**Subject: Convenience Store and Fuel Station Development
2282 Congress Street
Final Site Plan Application
Response to Preliminary Review Comments Dated April 10, 2013**

PRELIMINARY REVIEW COMMENTS – EMAIL APRIL 10, 2013

**WATER QUALITY/STORMWATER MANAGEMENT, ETC. REVIEW COMMENTS –
WOODARD & CURRAN DATED APRIL 18, 2013**

Excerpt from 4th Edition ITE Parking Generation Manual

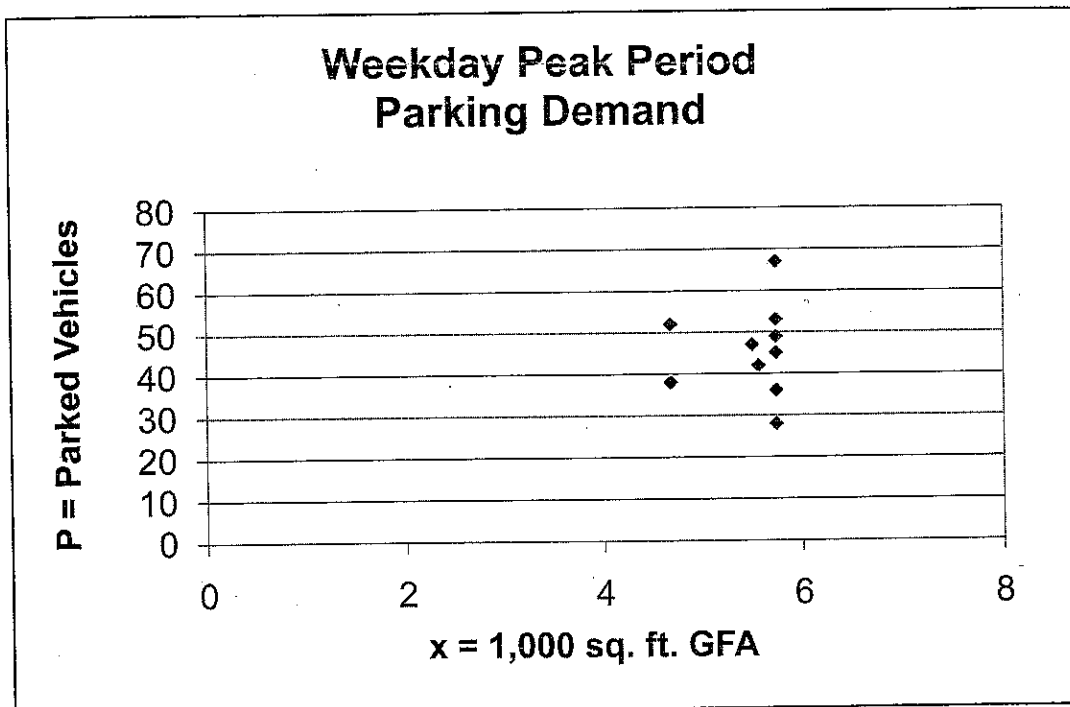
The area of pavement: The area seems excessive, especially in light of the reduced program (bank has been omitted); we would like to see a justification for the following:

- *The number of parking spaces: there appear to be about twice the zoning requirement – this triggers the need for a parking analysis (Ordinance requirement Section 14-526 (a) (4) a. 3.) which should be submitted asap (also please confirm the proposed number of spaces – the plan states 33 while the application data sheet says 32);*
- *Bicycle Parking: if you are not proposing to provide the required number of bicycle spaces you need to request a waiver with evidence of why the development is expected to generate reduced demand (see 14-526 (a) (4) b) – bicycle parking would be for both employees and customers;*
- *The aisle widths: some substantially exceed the City's technical standards and we would like to see turning templates and other information that explains the need for such wide aisles. Please clarify if one-way or two-way traffic movement especially on west side.*

Parking supply seems excessive for the type and scale of the proposed land use. Supporting documentation on the parking needs shall be provided.

The number of parking spaces proposed exceeds the number of spaces required by the City of Portland Land Use Code as referenced above because of the anticipated peak hour parking demand for this type of use. The applicant feels this is the proper amount of spaces to create a convenient and successful development. The parking demand can be supported by projecting the number of spaces required during the peak hour. The following table uses the 4th Edition ITE Parking Generation Manual to compute parking demand (excerpt attached).

TABLE 1 – PARKING DEMAND – ITE PARKING GENERATION					
Proposed GLA (SF)	Proposed GLA (1,000 SF)	Average Peak Period Demand Per 1,000 SF GLA (Weekday)	# of Spaces Required at 2282 Congress Street Based on Peak Demand (Weekday)	Average Parking Supply Ratio Per 1,000 SF GLA of Study Sites	# of Spaces Required Based on Comparison to Study Sites
3,850	3.85	8.38	32.26	13.1	50.4

As demonstrated in the table above, the parking demand is anticipated to require approximately 32 to 50 spaces. Although the site plan exceeds the City requirements for proposed parking spaces, our office feels the applicant has minimized the parking to the extent practicable.

FIGURE
 AT-1

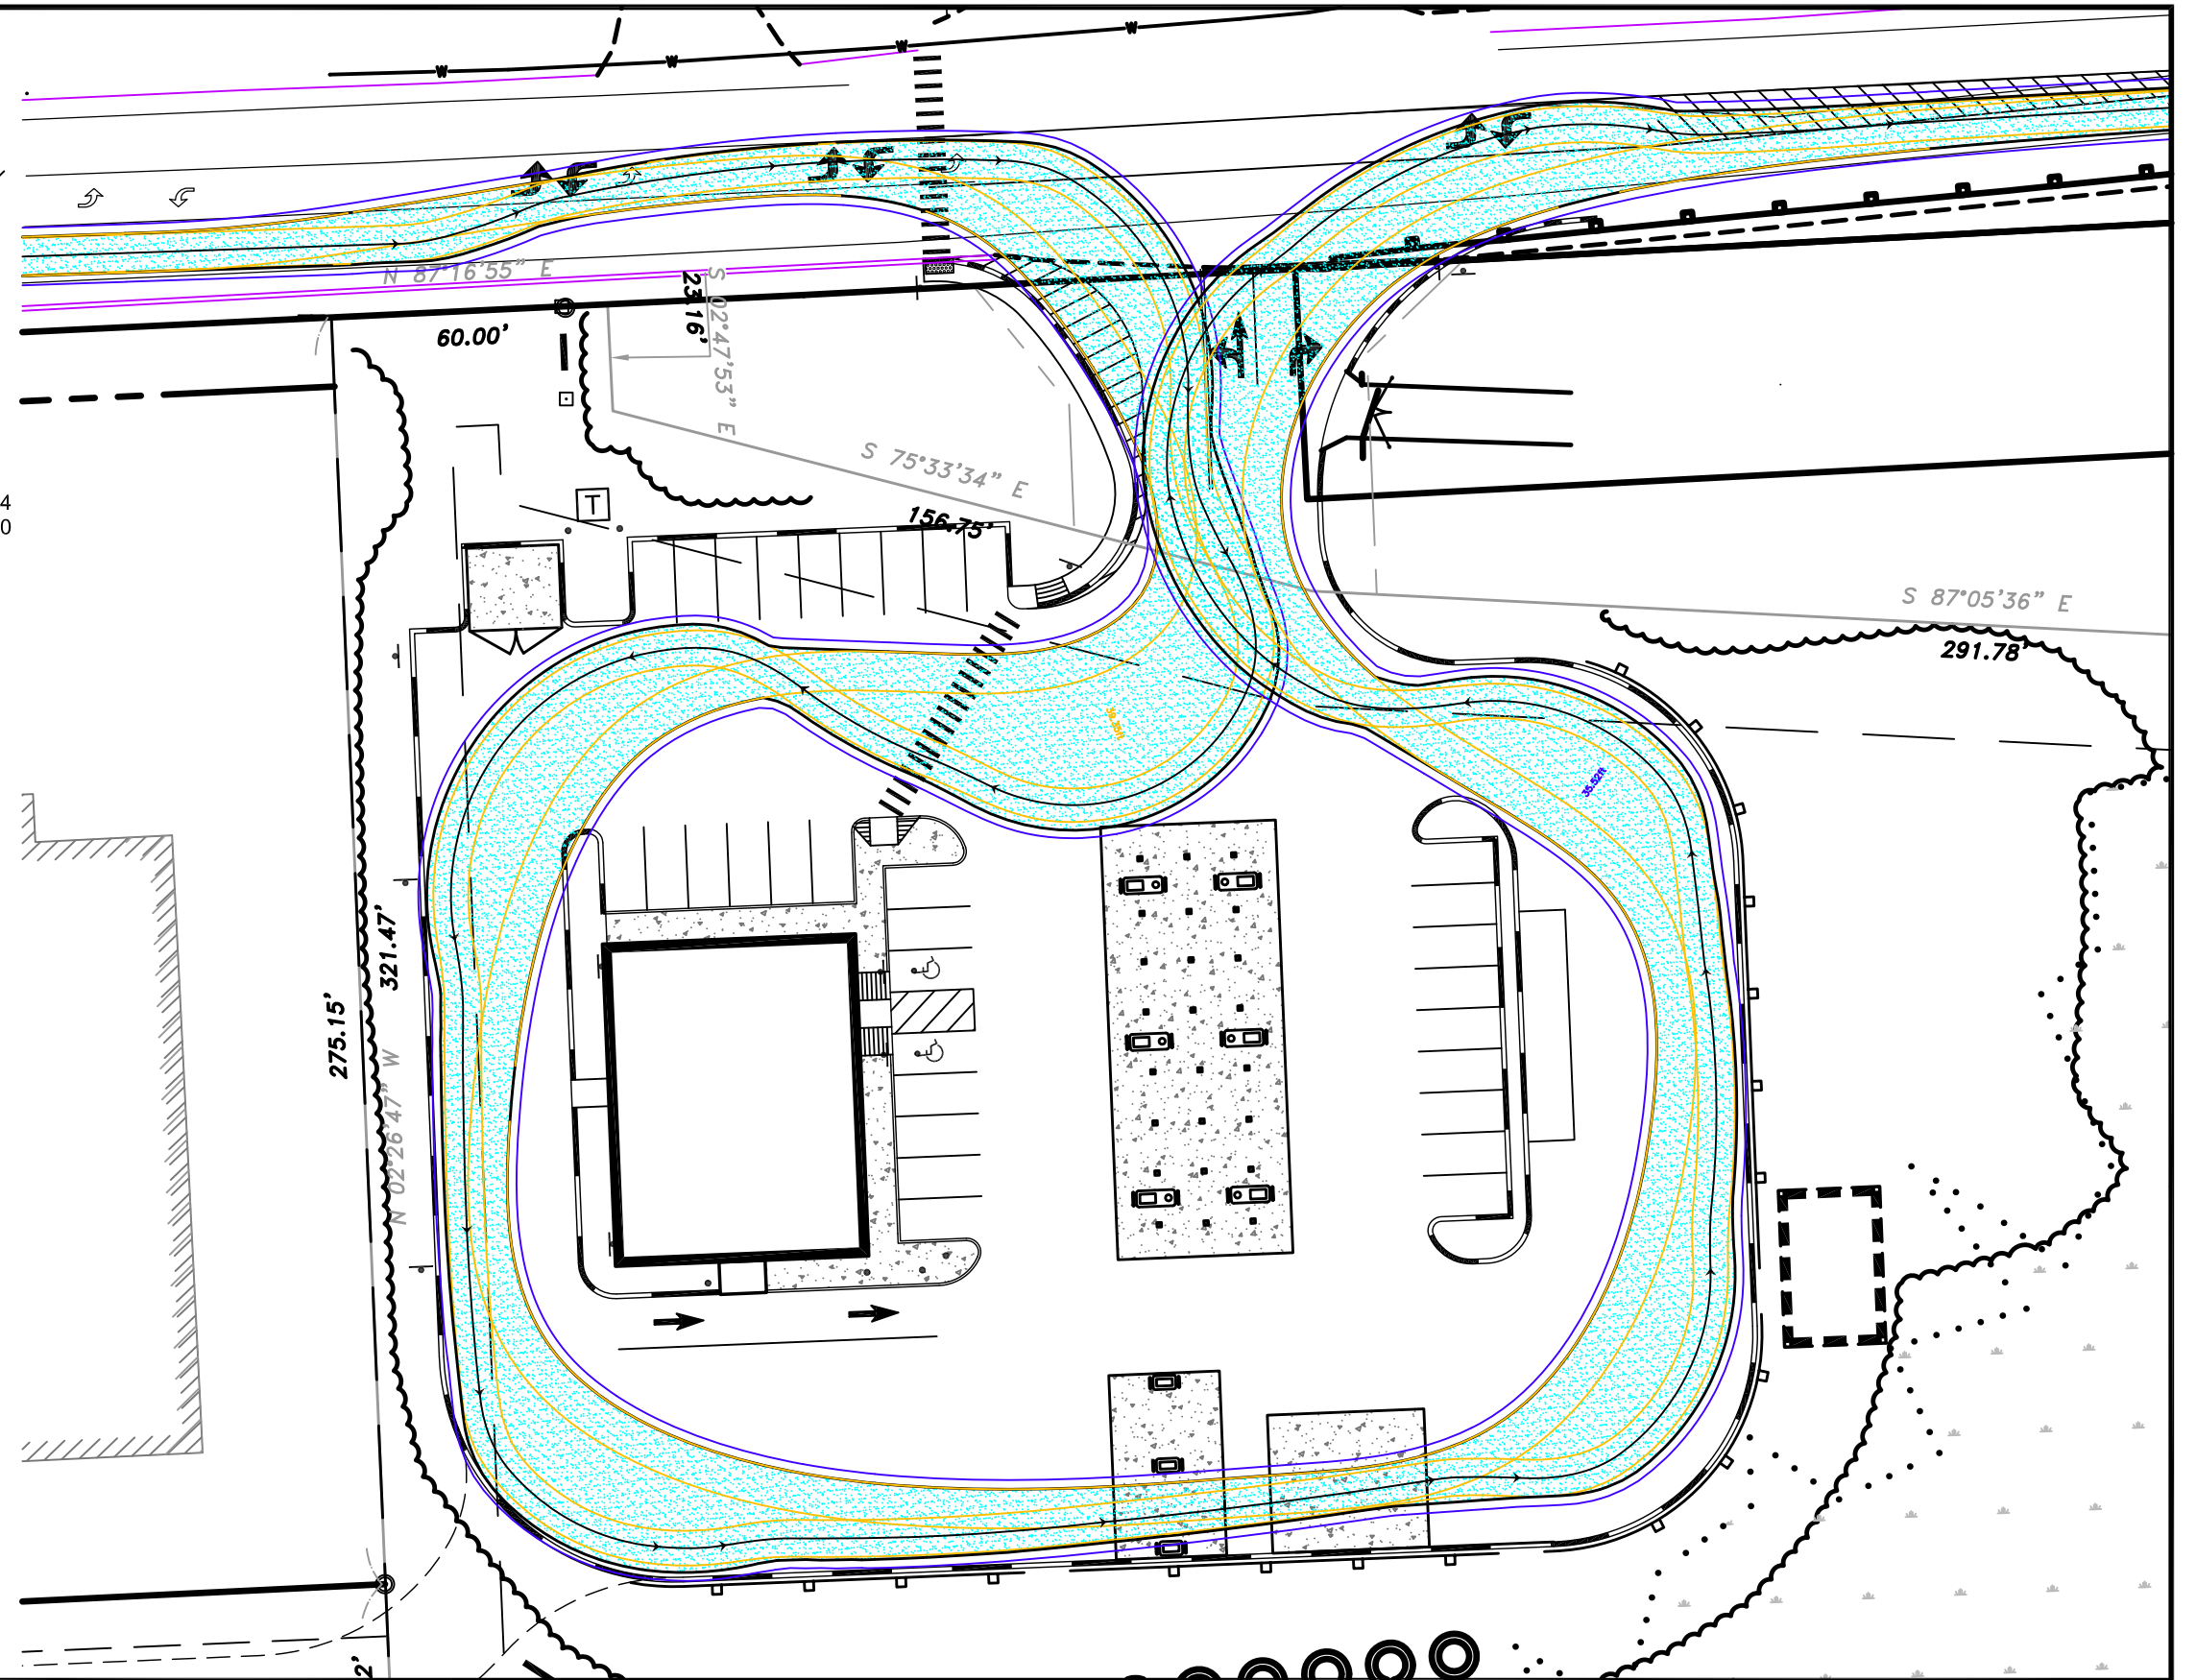
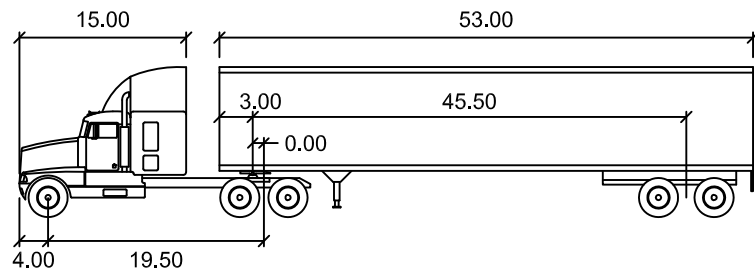
Auto-turn analyses shall be provided that supports on-site circulation aisle widths and the width of the driveway entrance on Congress Street. The applicant should also provide information on the number of large trucks anticipated to enter and exit the site.

Many aisle widths exceed City standards and waivers from our technical standards may be necessary. As noted above, supporting information will be required before I render any decision on waivers.

The AutoTurn analyses for large vehicles (WB-67 tractor trailers and fire trucks) are enclosed with this letter. Based on the site's location, large semi-trailers are expected to commonly visit the site thus warranting a good circulation layout.

The enclosed figures of the AutoTurn simulation for large vehicles supports the need for the proposed pavement aisle widths.

FIGURE
AT-3

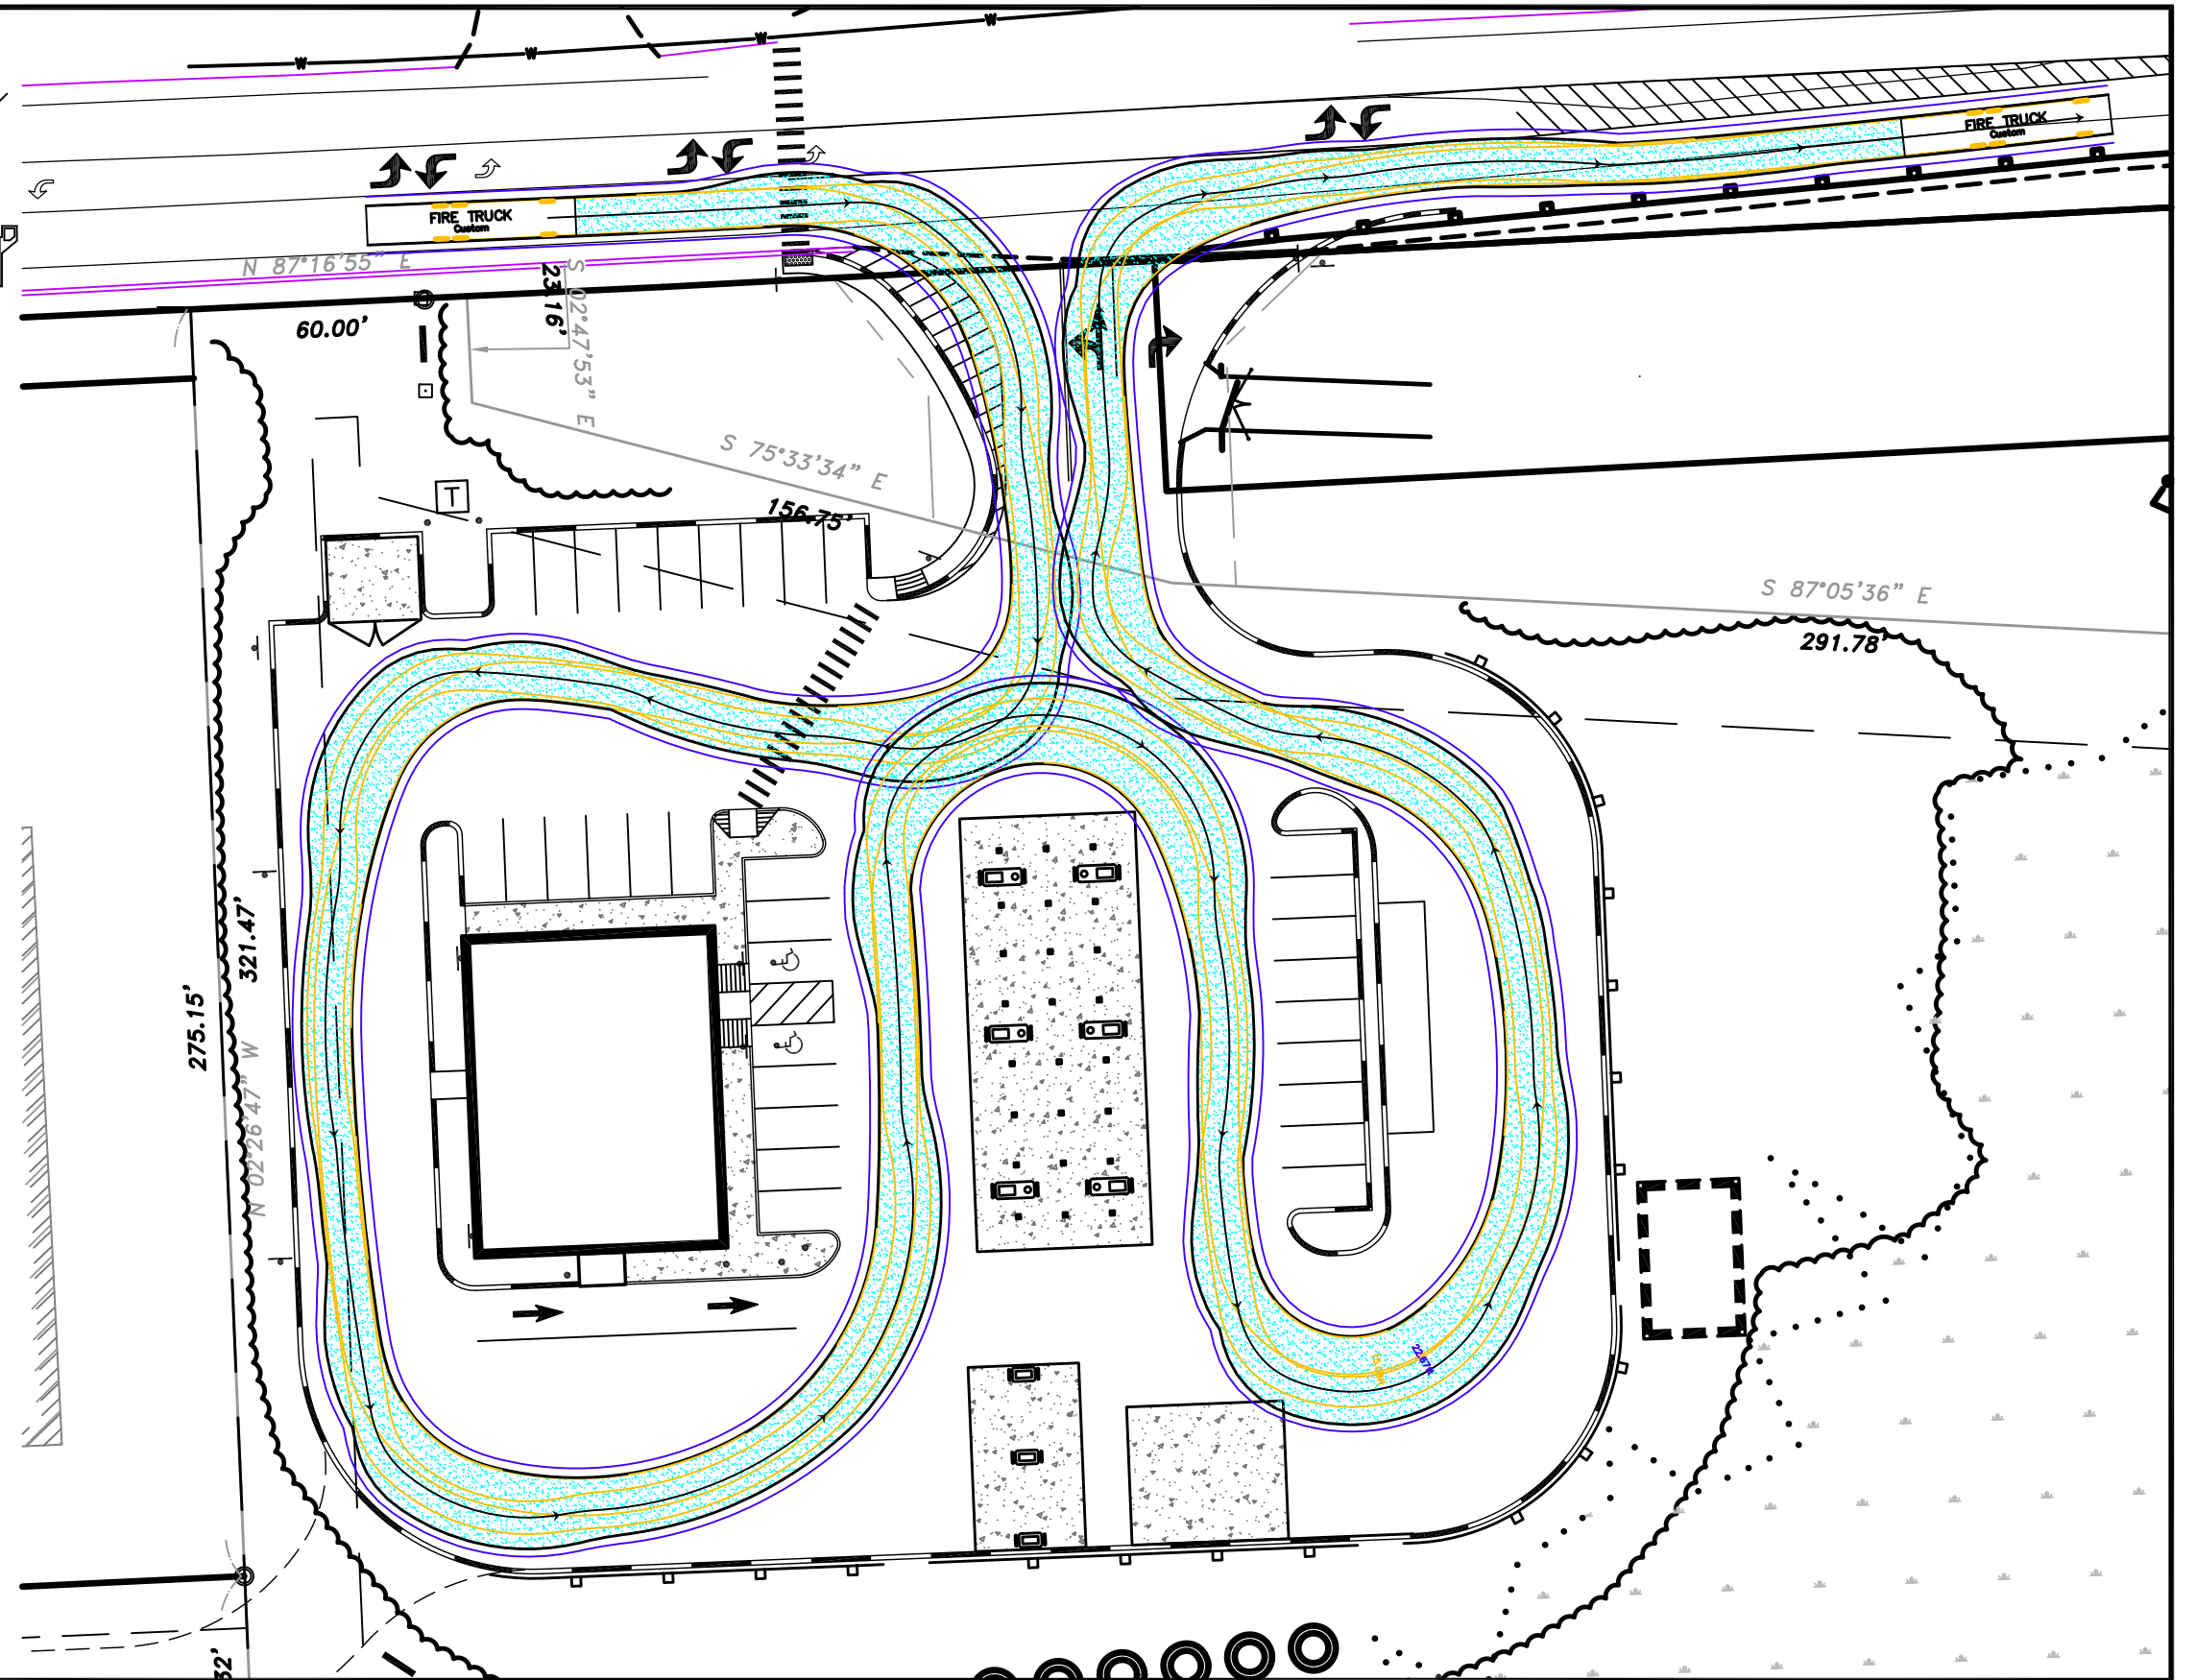
Fire Department issues: You have outlined in a letter dated April 1 to Captain Chris Pirone how the project addresses Fire Department issues and I suggest you contact him asap to further clarify the proposals so he can determine whether the site plan is satisfactory.

Our office has prepared the enclosed figure which shows a fire truck maneuvering around the site. Captain Pirone has verbally outlined the following related to the Fire Department review:

1. State Fire Marshall approval is required.
2. Access routes shall be a minimum of 20' wide.
3. The fuel canopy overhang clearance shall be at least 13'-1". We are providing a clearance of 14'-6".
4. There shall be a fire hydrant in close proximity to the site. The nearest hydrant is on Congress Street and is located directly opposite the site's northwest corner. The hydrant is located approximately 270' from the building.
5. The building does not require a sprinkler system nor is one proposed.
